ON THE CLARIFICATION OF CERTAIN TECHNICAL SOLUTIONS PRESENTED IN THE ENVIRONMENTAL IMPACT ASSESSMENT PROCEDURE ON THE IMPLEMENTATION OF THE NEW NUCLEAR POWER PLANT UNITS AT THE PAKS SITE AND ASSESSMENT OF THE ENVIRONMENTAL IMPACTS THEREOF

06 July 2016

On the clarification of certain technical solutions presented in the Environmental Impact Assessment procedure on the implementation of the new nuclear power plant units at the Paks site and the assessment of the environmental impacts thereof

Figure 2.1-1: Comparison of the earlier and more preciselly specified sites assessed

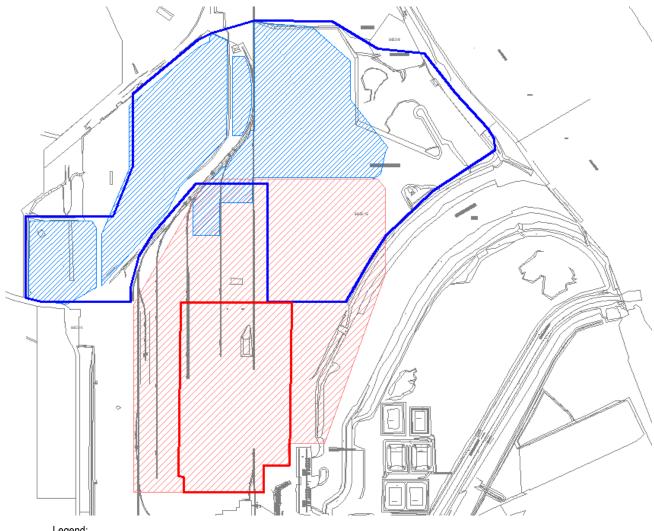
The units' buildings shifted to the north and their size increased, therefore the size and position of the operational and staging areas of the new units within the industrial economic area (hereinafter referred to as GIP area) are specified.

The comparison of the previously presented site and the more precisely specified one can be seen on the figure below. The previously presented areas are marked using dark lines, while the more precisely specified areas of 2016 are marked with a thin line and cross-hatched.

The size of the units' buildings increased, location of the units within the site is shifted to the north therefore the units are positioned farther from the operating units.

Figure 2.1-2: General site-ayout including the Paks Nuclear Power Plant site

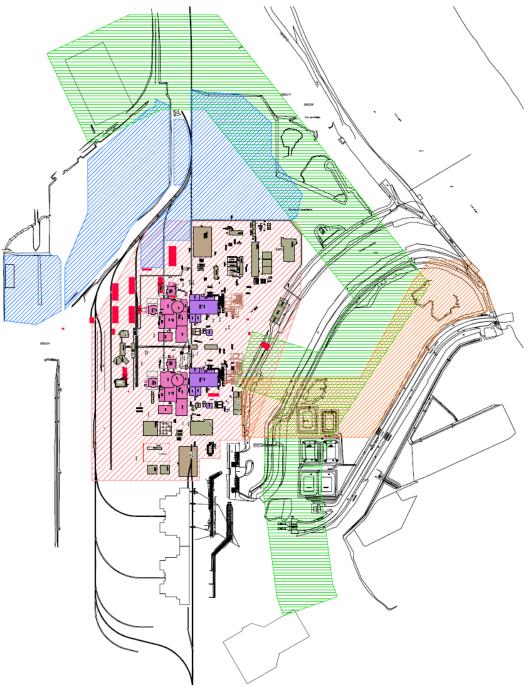
The location of Paks II. substation is modified, thus the length of the 400 kV unit lines and the 132 kV back-up feeder line will be reduced.

The optimal site for Paks II. substation in terms of feasibility and safe electric power supply was a location situated ~1.0 km to the north from the proposed site of the nuclear power plant units of Paks II., along the Main Road No 6. Construction of transmission lines with a length of 2,5-3 km is necessary between units 5 and 6 and the Paks II. substation as shown in Figure 2.1-2.

Figure 3.4-3: Cumulative impact area of the constructions

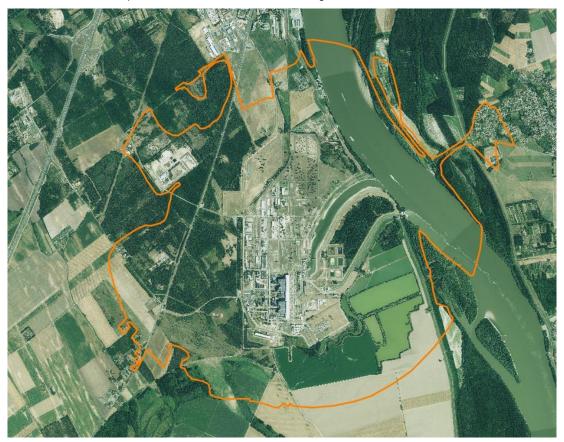
The cumulative impact area of the construction is the cumulative area of the transmission line constructions and that of the construction works on the operation area, as illustrated on the figure below.

Figure 3.7-1: Cumulative impact areas of the phases of constructions according to the EIA Report prepared in 2014 and based on the assessment of the specified technical solutions in 2016

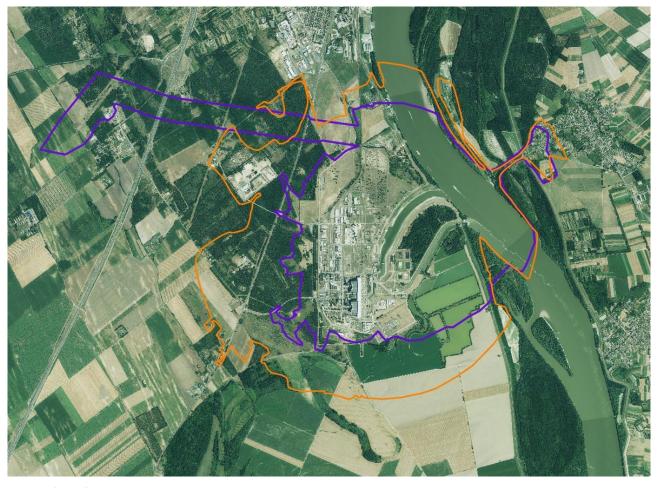
The cumulative impact areas of the phases of the constructions according to the EIA Report prepared in 2014 and based on the assessment of the specified technical solutions in 2016 are shown in the figure below.

Based on the results of the assessment, it can be seen that the spatial extent of the impact area of the constructions increased with respect to the plant site and decreased in the case of the transmission lines compared to the impact areas presented in the EIA Report.

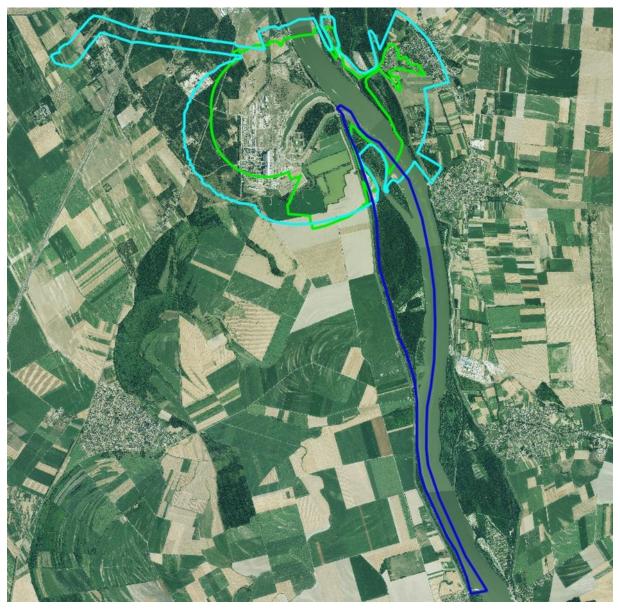
The cumulative impact areas of the operation based on the EIA Report prepared in 2014 and on the assessment of the specified technical solutions in 2016 are illustrated below.

Based on the results of the assessment, it can be seen that the spatial extent of the impact area of the operation is decreased with respect both to the site and the transmission lines compared to the impact areas presented in the EIA Report.
